Access Compliance Report

Public Rights-of-Way

(Curb Ramps)

Intersection ID: 28318	Main Street: ALBURY_WALK_LN	Cross Street: CASTLEBAY_DR	Location: NE
ADA ID: F881A5A68EA6	Ramp Type: Perp	Initial Pass/Fail: Fail	Overall Compliance: No
Severity Score: 12.5			
Codes/Mitigation Info/Possible Solution		Field Measurements/Component Compliance

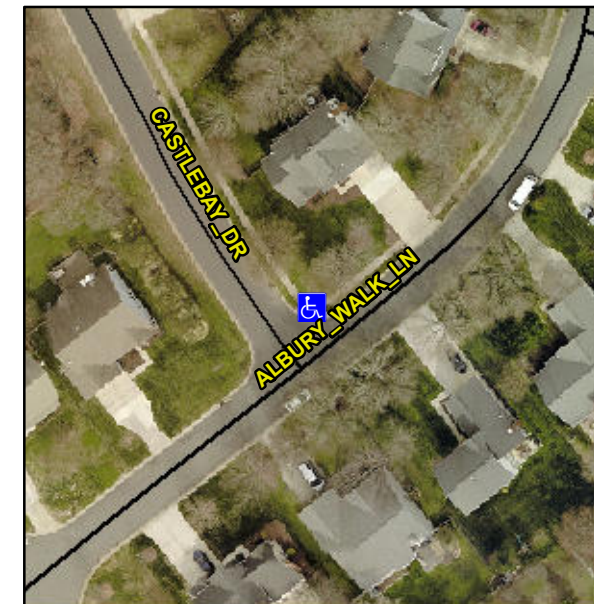
Not Found, R304.2.2

Compliance	Description	Data	Compliance	Description	Data
N/A	Ramp Length (in)	43.0	No	Ramp Slope (%)	9.1
Yes	Ramp Width (in)	75.0	Yes	Ramp XSlope (%)	0.2
N/A	Flare Type LT	N/A	N/A	Flare Type RT	N/A
N/A	Flare Slope LT (%)	N/A	N/A	Flare Slope RT (%)	N/A
N/A	Flare Traversable LT?	N/A	N/A	Flare Traversable RT?	N/A
N/A	Landing Length (in)	N/A	N/A	DWS Provided?	N/A
N/A	Landing Width (in)	N/A	N/A	DWS Contrast?	N/A
N/A	Landing Slope (%)	N/A	N/A	DWS Length (in)	N/A
N/A	Landing X Slope (%)	N/A	N/A	DWS Full Width?	N/A
N/A	Landing Curb? (Y/N)	N/A	N/A	DWS Offset (in)	N/A
N/A	Shared Landing?	N/A			
N/A	Gutter Ponding?	N/A	N/A	Gutter Slope (%)	N/A
N/A	Gutter Lip Ht (in)	N/A	N/A	Gutter X Slope (%)	N/A
N/A	Painted X Walk1?	No	N/A	Painted X Walk2?	N/A
	X Walk 1 Direction	To SW		X Walk 2 Direction	N/A
N/A	X Walk 1 Width (in)	N/A	N/A	X Walk 2 Width (in)	N/A
	X Walk 1 Slope (%)	1.6		X Walk 2 Slope (%)	N/A
	X Walk 1 X Slope (%)	1.4		X Walk 2 X Slope (%)	N/A

Remove & Replace Entire Ramp.
